SUBJECT: INDIAN POINT NUCLEAR GENERATING UNIT NOS. 2 AND 3 - STAFF ASSESSMENT OF INFORMATION PROVIDED PURSUANT TO TITLE 10 OF THE *CODE OF FEDERAL REGULATIONS* PART 50, SECTION 50.54(f), SEISMIC HAZARD REEVALUATIONS FOR RECOMMENDATION 2.1 OF THE NEAR-TERM TASK FORCE REVIEW OF INSIGHTS FROM THE FUKUSHIMA DAI-ICHI ACCIDENT (TAC NOS. MF3717 AND MF3718)

STAFF ASSESSMENT BY THE OFFICE OF NUCLEAR REACTOR REGULATION

RELATED TO SEISMIC HAZARD AND SCREENING REPORT

INDIAN POINT ENERGY CENTER, UNIT NOS. 2 AND 3

Figure 3.3-1 Plot of Staff's and Licensee's Base Case Shear-Wave Velocity Profiles

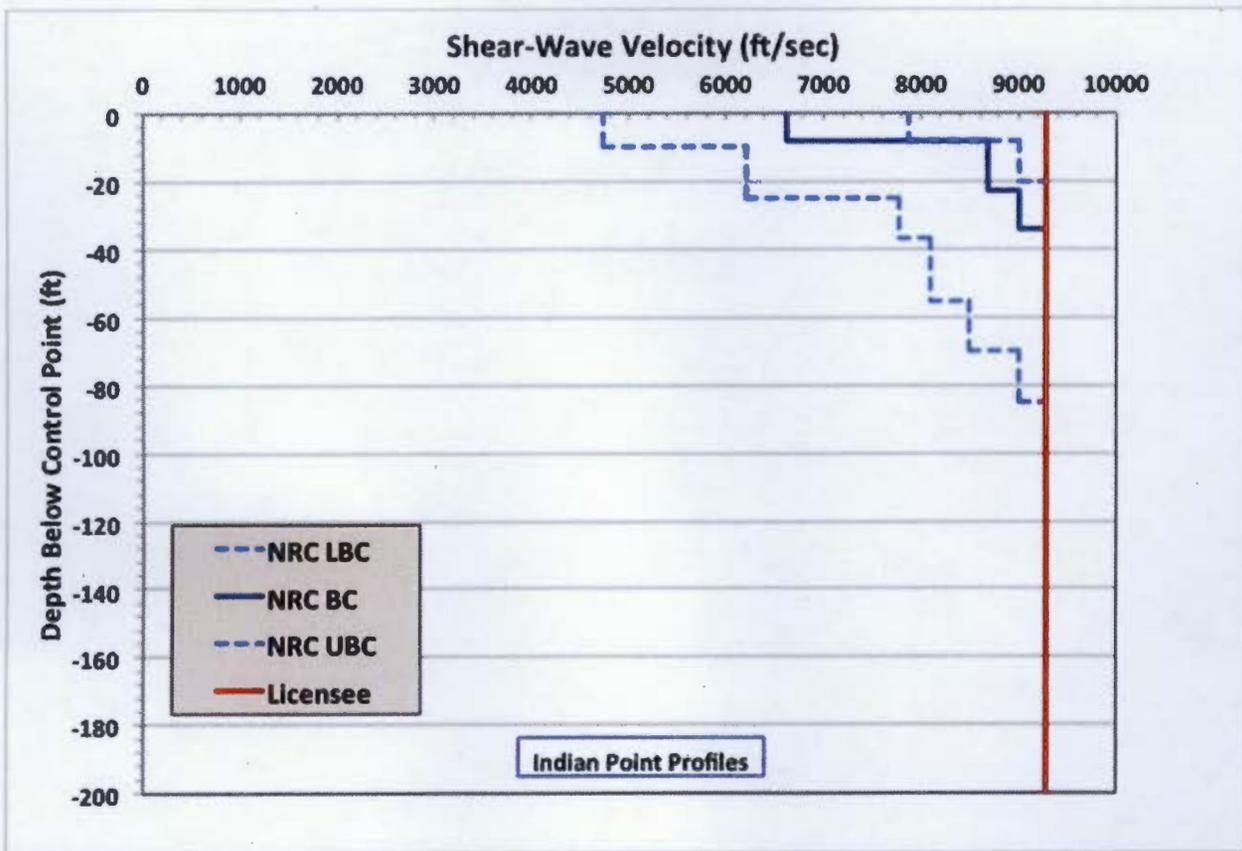
The staff used the information summarized above to develop a range of near-surface firm rock shear velocity estimates for the Indian Point site. As these velocities range from 4,900 to 9,600 ft/sec (1,493 to 2,926 m/sec), the staff developed three base cases with velocity values at the control point of 4,900, 6,800 and 8,400 ft/sec (1494, 2073, and 2561 m/sec) for the lower, best estimate and upper base cases, respectively. The staff then used the SPID template velocity profiles for firm rock site conditions to extrapolate the near surface velocities to depth. Figure 3.3.1 of this assessment shows the three base case velocity profiles developed by the staff.

Figure 3.3-2 Comparison of the Licensee's and NRC Staff's Median Amplification Functions and Uncertainties (Sigma Ln(AF)).

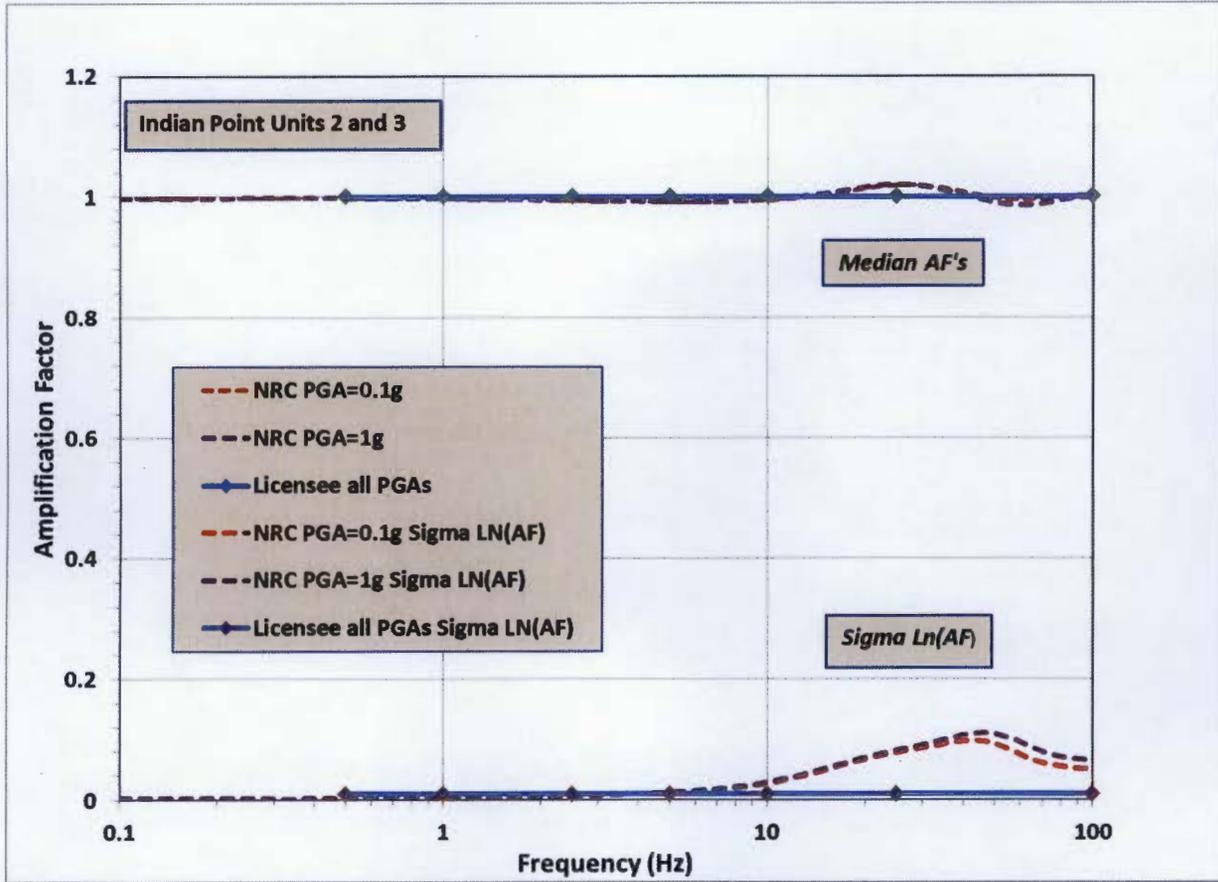
After randomizing each of the three base case profiles and implementing the random vibration theory (RVT) approach to perform the site response calculations, the staff developed site amplification functions. These amplification functions and associated uncertainties for two input loading levels are shown in Figure 3-3.2 of this assessment. The amplification functions produced using the staff's three base case models are very close to unity and the uncertainty is also relatively low, which is consistent with the licensee's determination that a site response analysis for this site is not warranted. Because the licensee did not perform a site response analysis, its amplification function is one and the uncertainty in the amplification function is zero.

Figure 3.3-3 Comparison of NRC Staff's and the Licensee's Mean Control Point Hazard Curves at Selected Frequencies

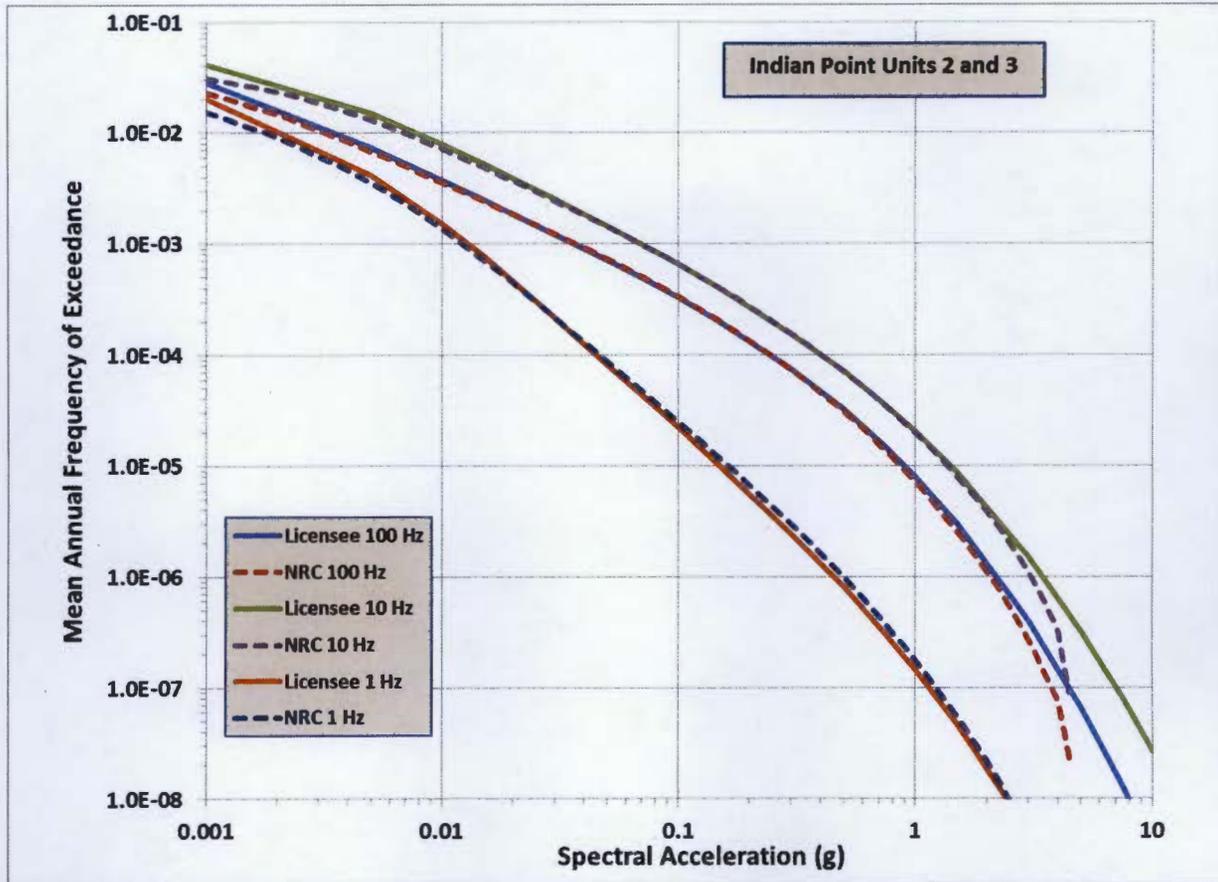
The NRC staff applied Approach 3, as described in Appendix B of the SPID, to compute the probabilistic site-specific control point hazard curves. Figure 3.3-3 of this assessment compares the NRC staff control point hazard curves in comparison to the licensee's hard rock hazard curves, presented in Section 2.3.7 of the SHSR submittal. As shown in Figure 3.3-3, the impact of the staff including the stiff near-surface materials in its site response analyses is generally minimal on the control point seismic hazard curves for mean annual exceedance frequencies greater than  $1 \times 10^{-6}$  per year.

In conclusion, as shown in Figure 3.3-3 of this assessment and discussed below, the staff's site response analysis does not produce significantly different control point seismic hazard curves or the resulting GMRS. Appendix B of the SPID provides guidance for performing site response analyses, including capturing the uncertainty for sites with less subsurface data; however, the guidance is neither entirely prescriptive nor comprehensive. As such, various approaches in performing site response analyses, including the modeling of uncertainty, are acceptable for this application.

In summary, the staff concludes that the licensee's evaluation was conducted using present-day guidance and methodology, including the SPID. The staff performed independent calculations which confirmed that the licensee's control point hazard curves adequately characterize the hazard for Indian Point.

Figure 3.4-1 Comparison of the Staff's GMRS with Licensee's GMRS and the Indian Point Unit No. 2 SSE

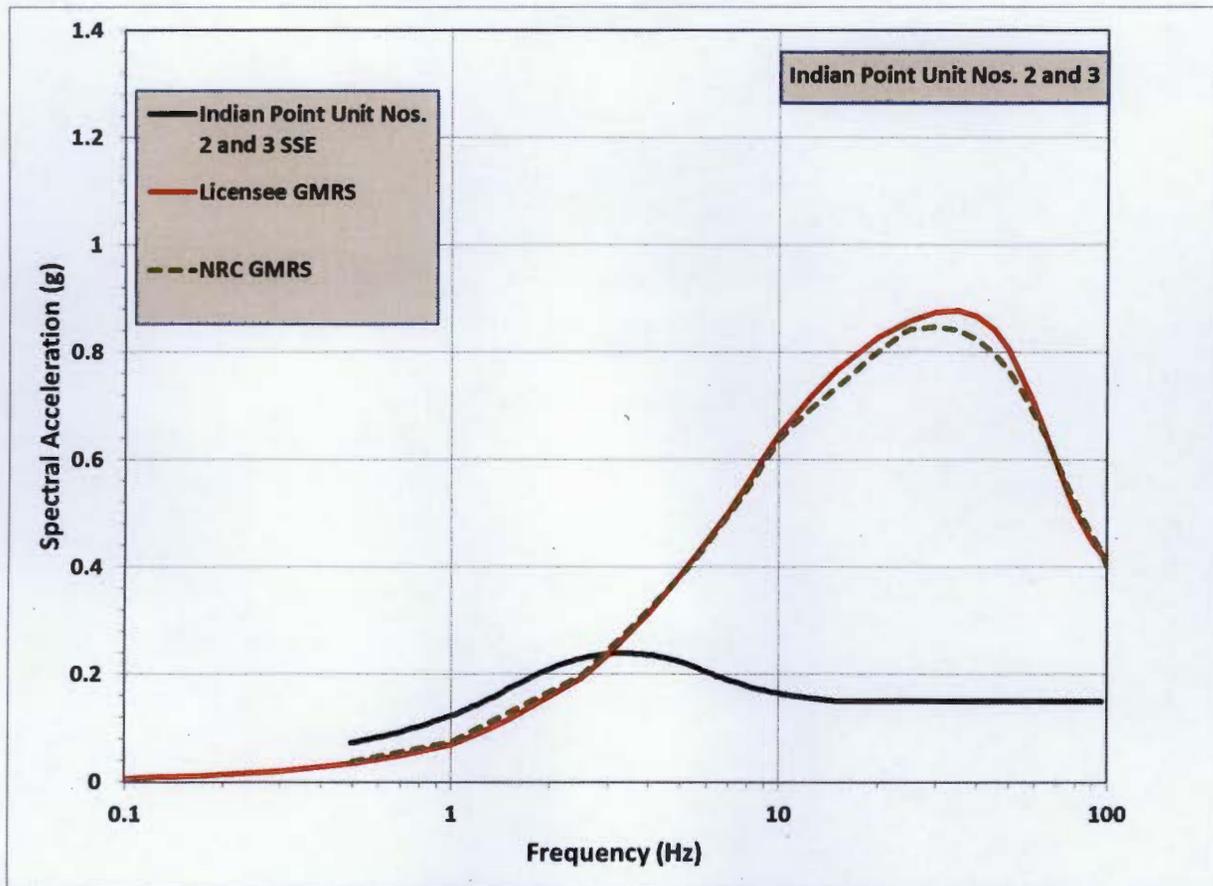
The staff independently calculated the  $10^{-4}$  and  $10^{-5}$  UHRS using the results of its confirmatory PSHA, as described in Sections 3.2 and 3.3 of this staff assessment, respectively. Figure 3.4-1 of this assessment shows a comparison of the GMRS determined by the licensee to that determined by the staff.

As shown in Figure 3.4-1 of this assessment, the staff's GMRS is very similar to the licensee's in both amplitude and shape. Both the licensee's and staff's GMRS exceed the SSE for both Indian Point Units 2 and 3 for all frequencies above 3 Hz. The staff confirms that the licensee used the present-day guidance and methodology outlined in RG 1.208 and the SPID to calculate the horizontal GMRS, as requested in the 50.54(f) letter. The staff performed a PSHA confirmatory

analysis and achieved results consistent with the licensee's results. As such, the staff concludes that the control point hazard curves (and GMRS) determined by the licensee adequately characterize the seismic hazard for the Indian Point, Units 2 and 3 site. Therefore, the licensee's hazard results are suitable for use in subsequent evaluations and confirmations, as needed, for the response to the 50.54(f) letter.
